REMEDIATION SYSTEM EVALUATION

DELPHI CORPORATION
VANDALIA, OHIO

Report of the Remediation System Evaluation,
Site Visit Conducted at the Delphi Corporation, Vandalia, Ohio Facility
March 6, 2003

EPA 542-F-04-023
June 2003
www.epa.gov/tio
clu-in.org/optimization

FIGURE 1-3. TCE DISTRIBUTION IN THE TOP OF ROCK

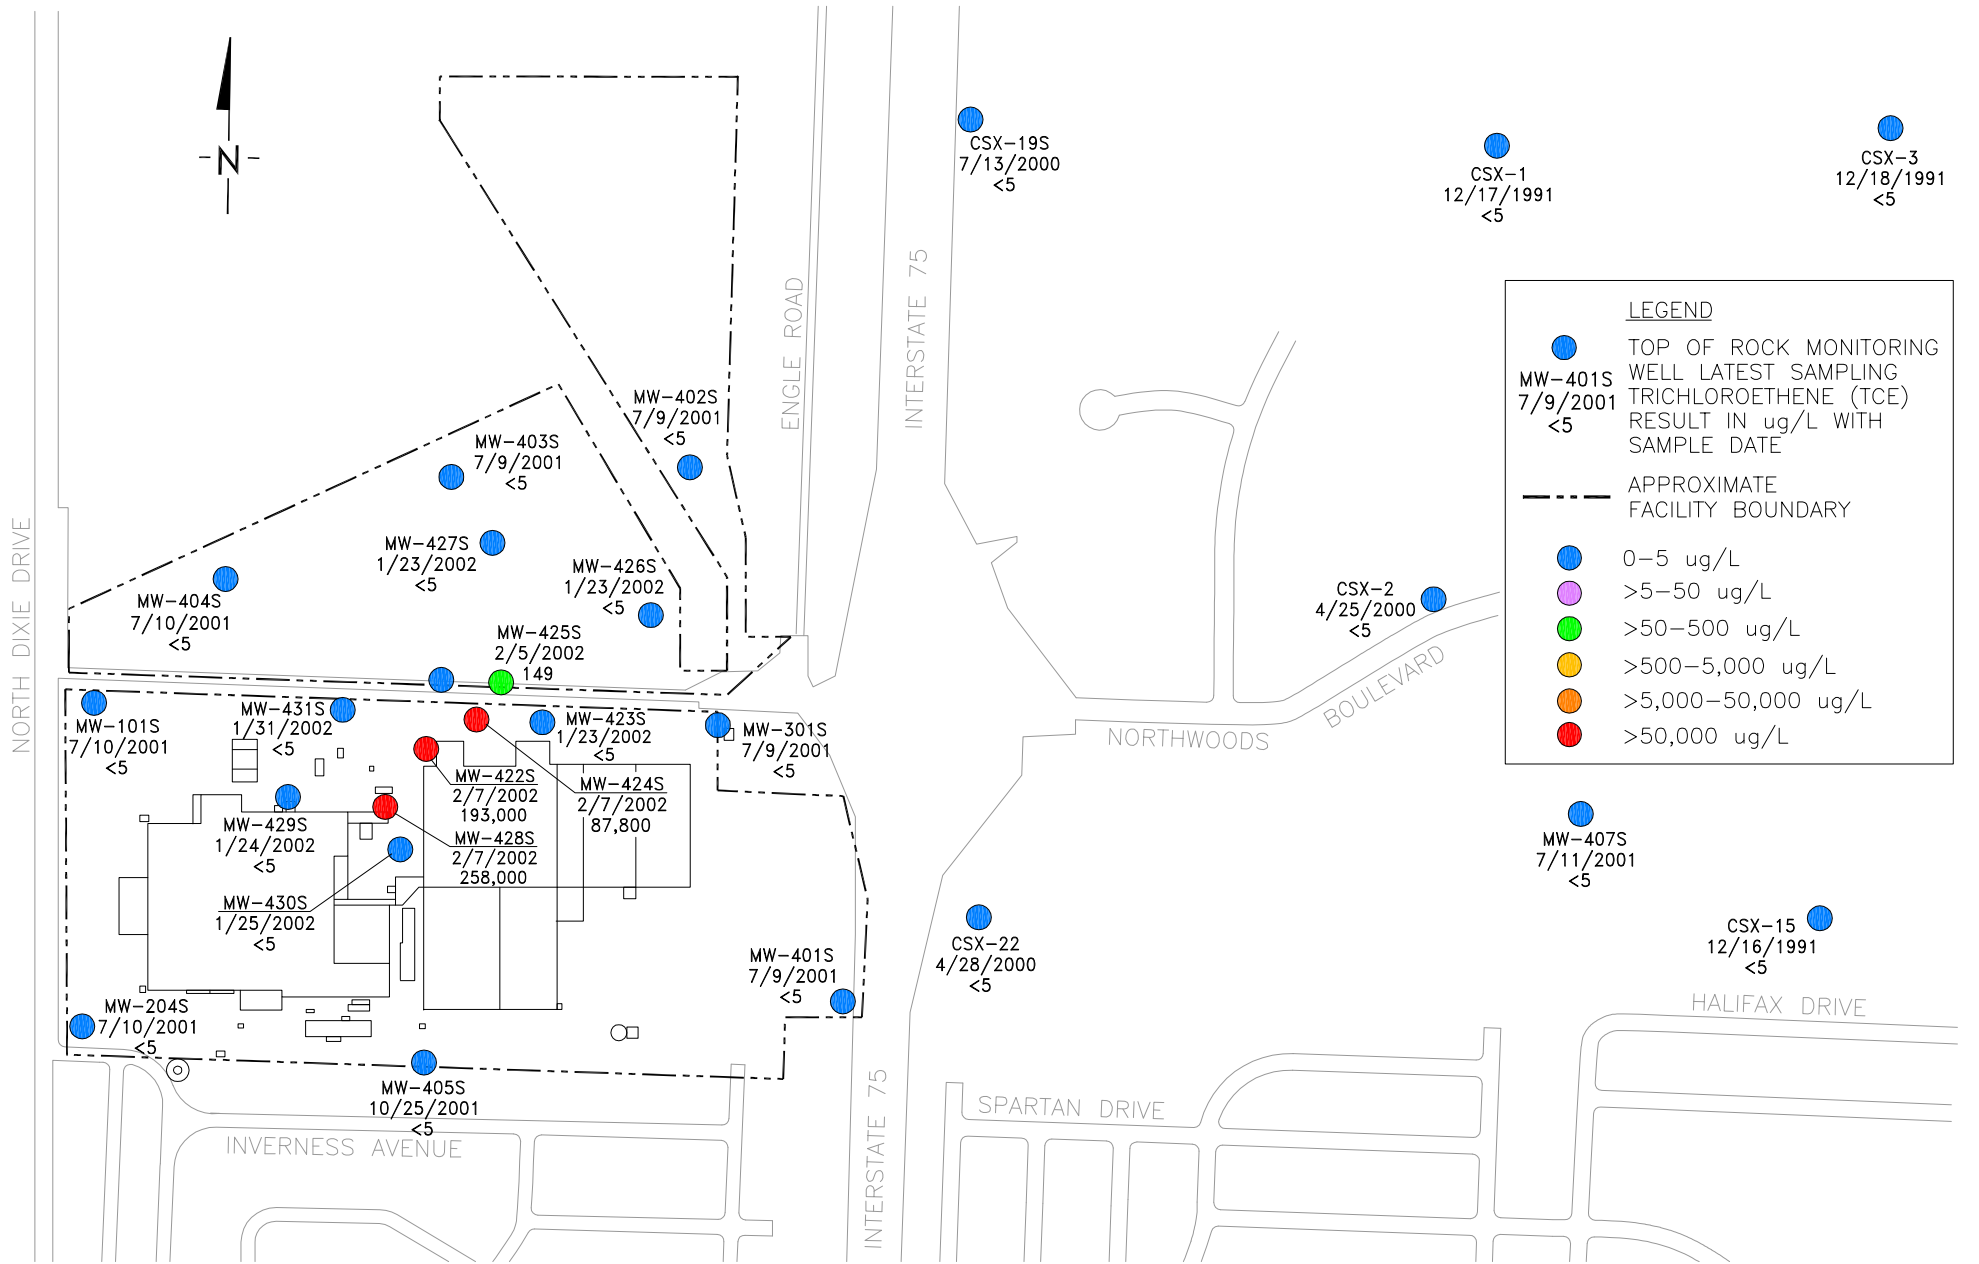
Dissolved ground water contamination in the Top of Rock zone (see Figure 1-3) appears to be controlled by a piezometric low near MW-424S (see Section 4.2.1 and 4.2.2 of this report) where water in the Top of Rock appears to discharge to the underlying Sugar Rock. Wells upgradient of this area historically have elevated TCE concentrations. For example, in the fourth quarter of 2002, MW-422S had a TCE concentration of 200,000 ug/L. Wells downgradient of this area (MW-423S, MW-445S, MW-446S, and others) have undetectable TCE concentrations. Although this piezometric low appears to capture site-related contamination within the Top of Rock aquifer, one supply well at a property located on Engle Road, located just north of the facility, has detectable concentrations of TCE that are below the MCLs. However, that well on Engle Road has an open intake that extends from the Top of Rock to the Sugar Rock, so the contamination at that well is likely drawn from the Sugar Rock.

In the Top of Rock, there is no intended target capture zone and no implemented remedy because contaminated water appears to be naturally contained by the discharge of water to the underlying Sugar Rock. As shown in Figure 1-3, ground water sampling and analysis in the Top of Rock suggests that VOC contamination above MCLs is limited to four wells in the north central portion of the property (MW-422S, MW-424S, MW-425S, and MW-428S). The sampling results from other monitoring wells in the Top of Rock and interpretation of capture from the potentiometric surface map suggest that the contamination in these wells is contained horizontally. The only indications of potential TCE or cis-1,2-DCE contamination in the Top of Rock that is likely outside of the capture zone are the sampling results from 10591 Engle Road, which is approximately 500 feet to the northeast of the facility and near the Unnamed Tributary. The concentrations at this location are below MCLs and all other wells in the area (both monitoring and supply wells) have no detectable concentrations of these constituents. This well is constructed with an open interval that extends from the Top of Rock to the Sugar Rock and it is likely that TCE in this well is related to the Sugar Rock.

FIGURE 1-4. TCE DISTRIBUTION IN THE SUGAR ROCK, FIRST QUARTER 2003

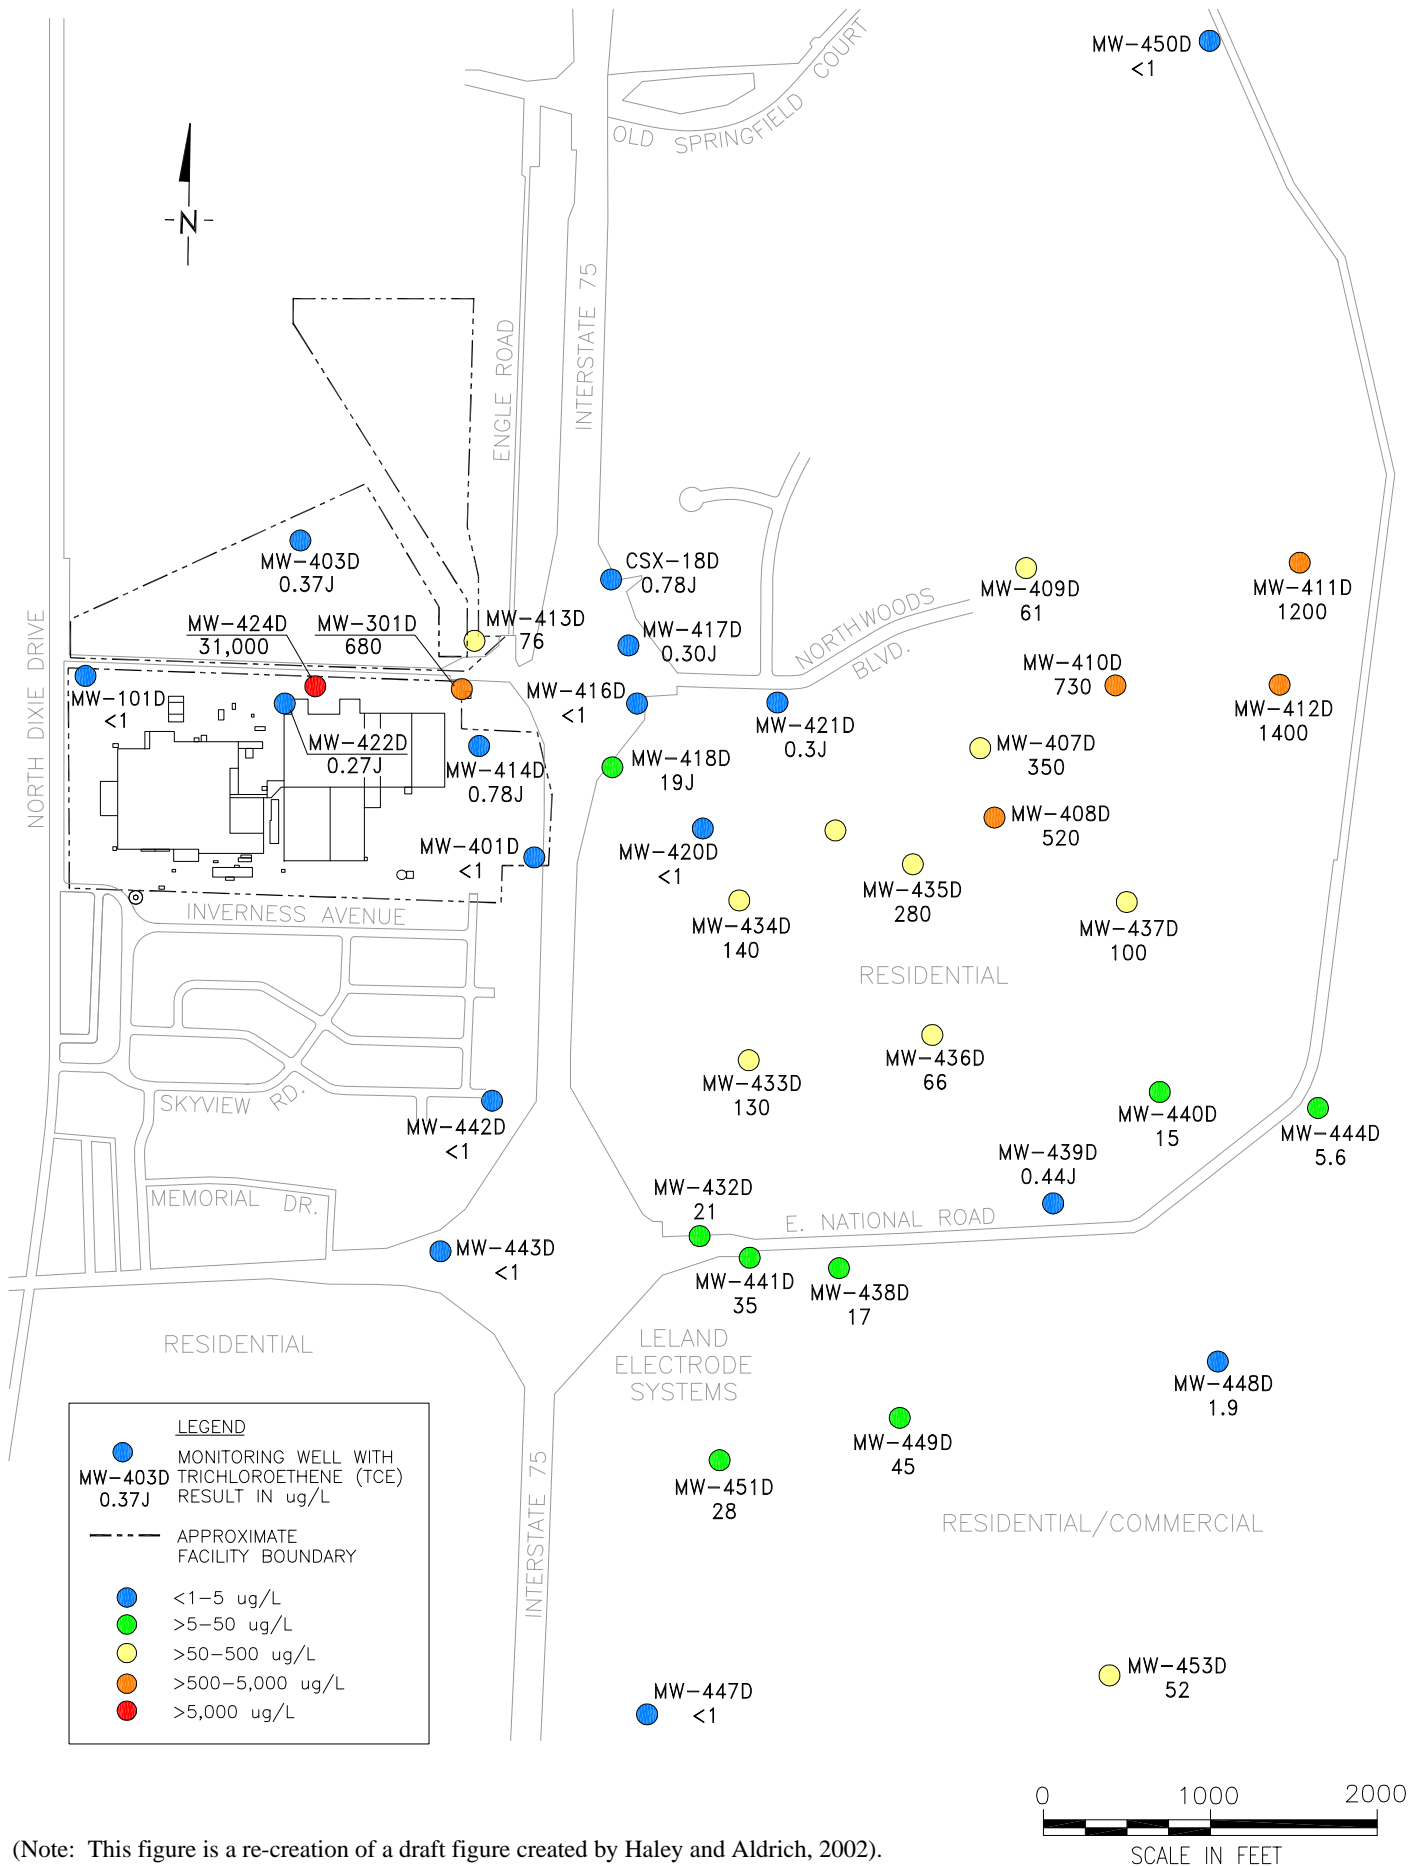
Ground water contamination in the Sugar Rock extends over a mile from the site to the east. The highest concentration in this unit is repeatedly detected at MW-424D (see Figure 1-4 for location), which is located in the area where TCE impacted water from the Top of Rock zone is suspected to enter the Sugar Rock through an old production well boring. During the fourth quarter of 2002, MW-424D had a TCE concentration of 30,000 ug/L. Elevated concentrations of cis-1,2-DCE and 1,1 DCA were also detected (5,000 ug/L cis-1,2-DCE and 290 ug/L 1,1 DCA). Concentrations offsite to the east decrease near P-301, which is the extraction well for the ground water migration control system, and then increase again approximately 3,000 feet from the facility. In the first quarter of 2003, the TCE concentrations along Cassel Road were over 1,000 ug/L (1,200 ug/L in MW-411D and 1,400 ug/L in MW-412D). Beyond these points ground water discharge through seeps to surface water that eventually empties into the Great Miami River.

FIGURE 4-1. POTENTIOMETRIC SURFACE MAP FOR THE TOP OF ROCK, JULY 2002

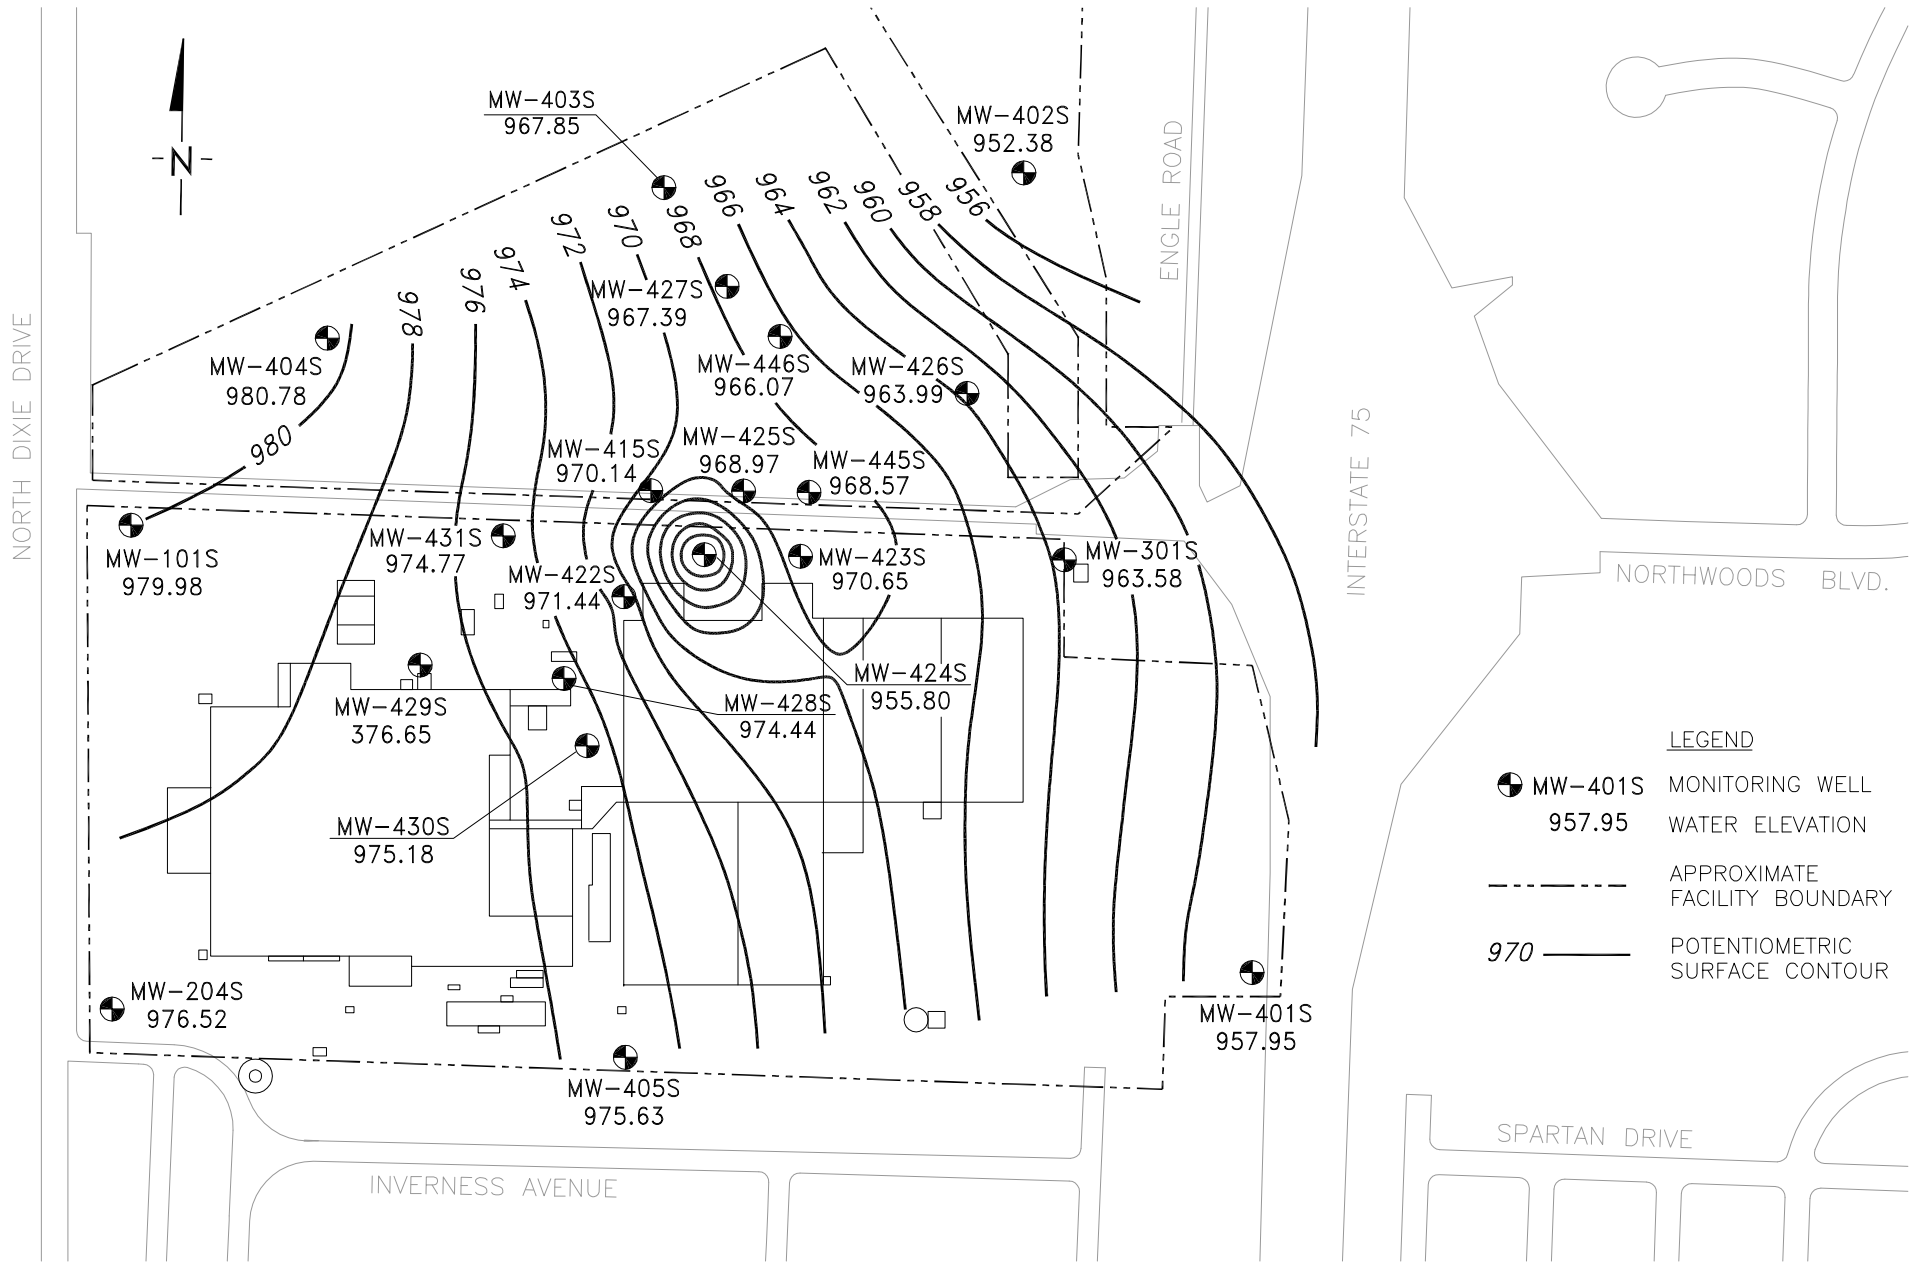
Water levels from the Top of Rock are collected quarterly and corresponding potentiometric maps are generated. Figure 4-1 depicts a typical potentiometric surface map for the Top of Rock unit. The regional water elevation ranges from approximately 980 feet above mean sea level (MSL) at the western property boundary to approximately 960 feet MSL at the eastern property boundary. A localized low in the water table is present at MW-424S where the water level is approximately 956 feet MSL. This low likely represents an area where water from the Top of Rock discharges to the Sugar Rock.
